PLN2019-00331 - 615 Lancaster Blvd.

SUBJECT: Coastside Design Review

615 Lancaster Boulevard, Moss Beach

APN 042-031-200; County File No. PLN 2019-00331

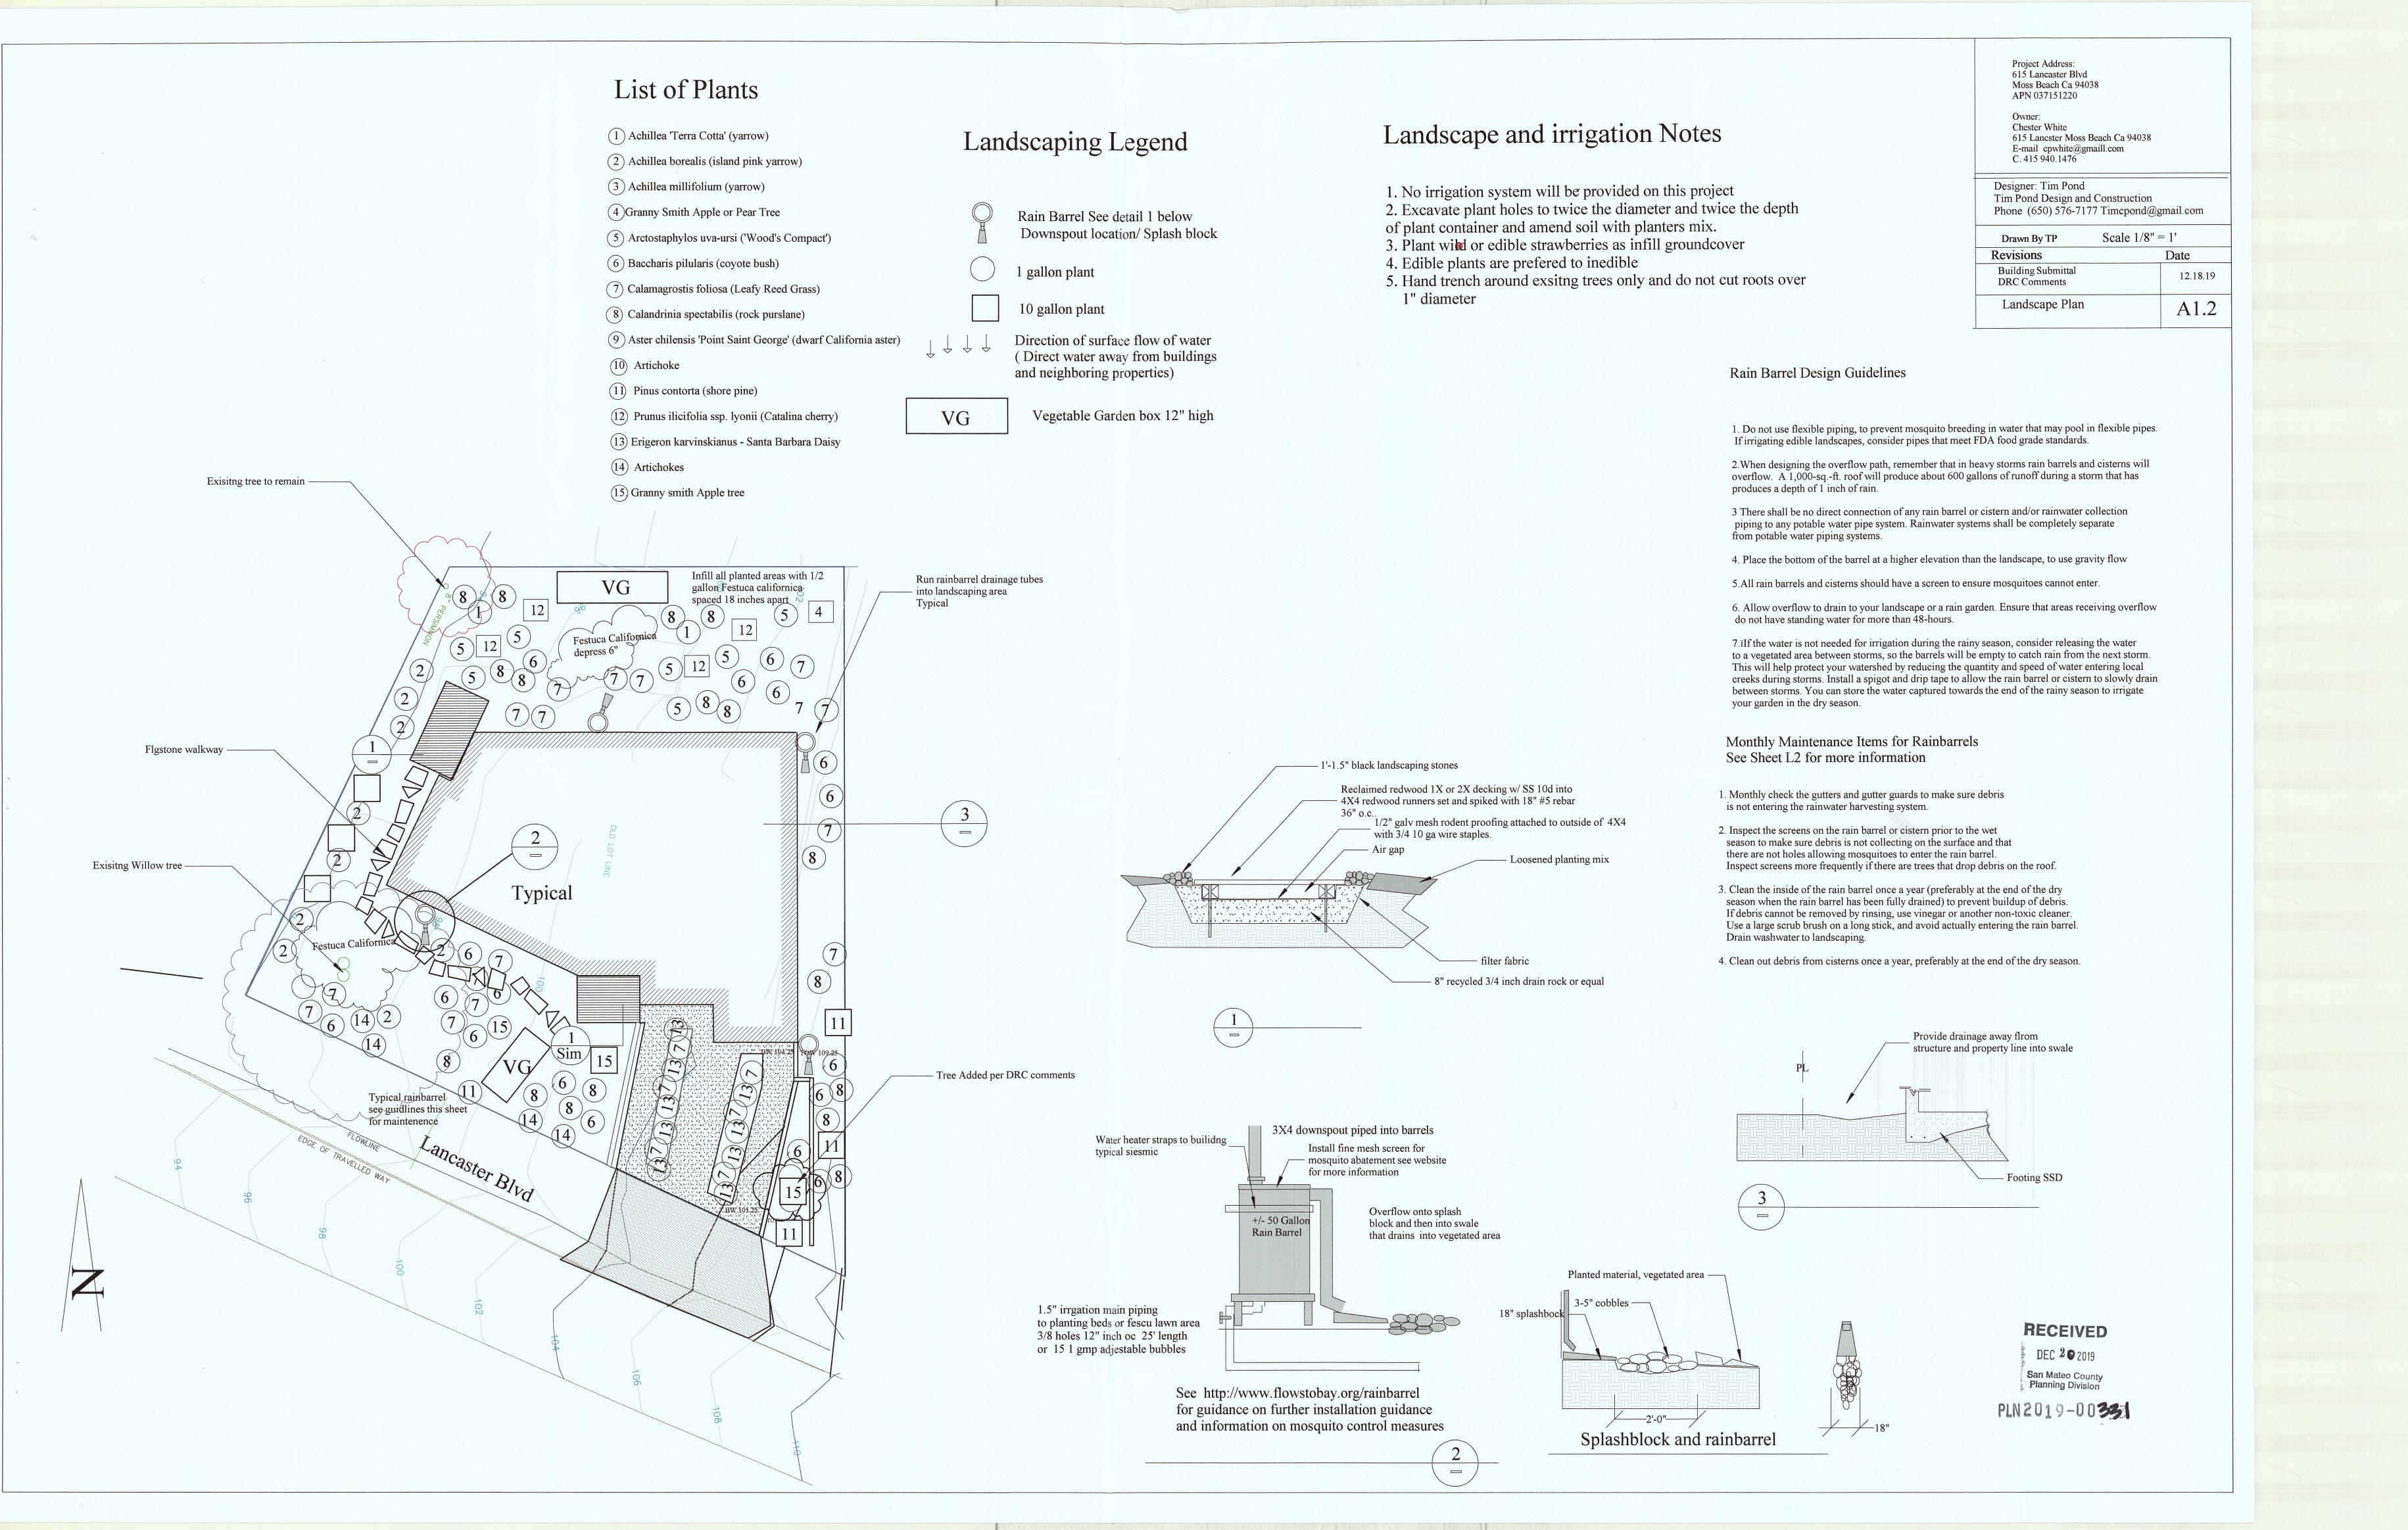
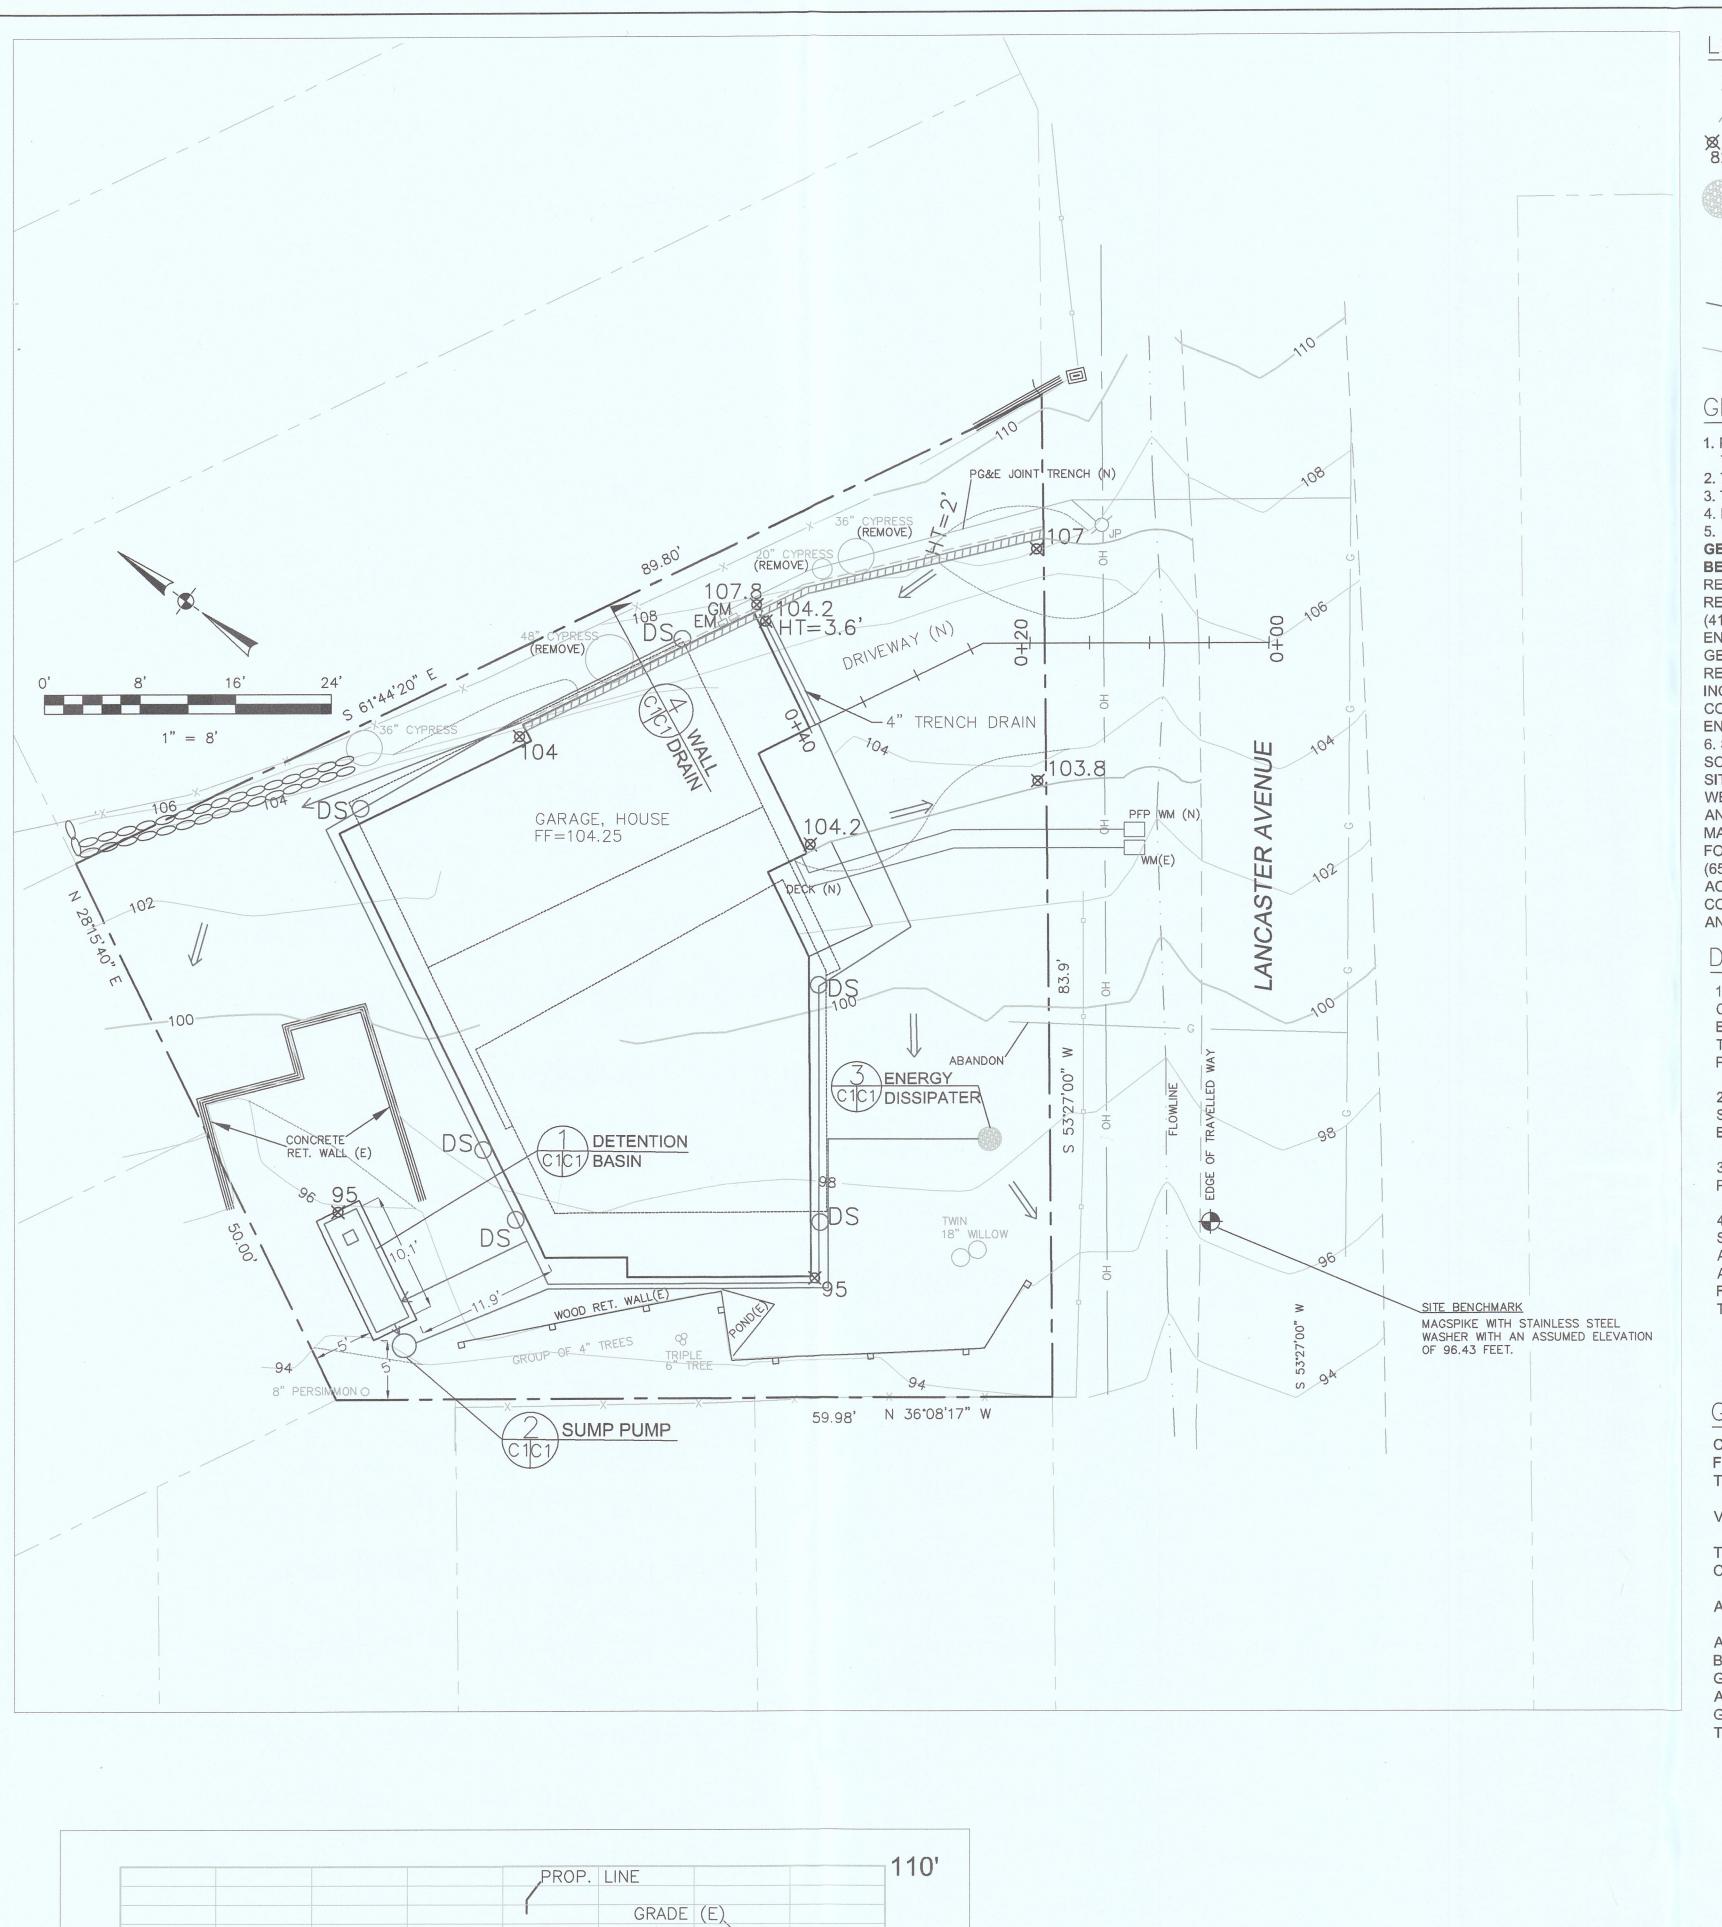
- 1. Add one light fixture only, to each door, on side.
- 2. Facia stone is fine. Specify manufacturer, type, and manufacturer's reference number and color.
- 3. Submit a grading and drainage plan prepared by a qualified professional.
- 4. Add a tree to the right side of driveway.
- 5. Shift multi-paned window on front of house upward or downsize window.
- 6. Provide detail for water table between stone and board & batten, including dimension of water table, dimension above finished floor elevation, and specify color. Carry water table band around entire building on all elevations, unless shed roof massing at stairs is intentionally separated for a more vertical aesthetic without water table band. If shed

- roof massing does not have water table band, adjust window location so it isn't placed at the transition of the massing.
- 7. Proposed house colors are satisfactory, specify manufacturer, manufacturer's reference number and color.
- 8. Add call-outs to all elevations for materials, colors and finishes.
- 9. Show gutters and downspouts.
- 10 Floor plans need to be complete. Graphic information such as dimensions stings need to be cleaned up for clarity.
- 11. All elevation drawings need to have graphic representations of materials in addition to (at a minimum) typical material callouts on one elevation with manufacturer specifications and colors.
